REMARKS/ARGUMENTS

Application No.: 09/752,243 Amendment Dated: April 29, 2004 Reply to Office Action of January 29, 2004

ANNOTATED SHEET SHOWING CHANGES

FIG. 1

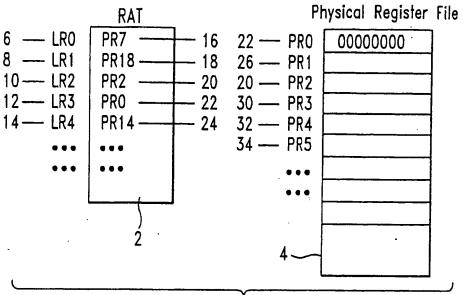
The Examiner has objected to the drawings as not showing the features in claims 11 and 12. Figure 3 has been added listing examples of zeroing instructions. Figure 3 is identical in content to the table shown on page 5 of the specification, thus adding no new matter.
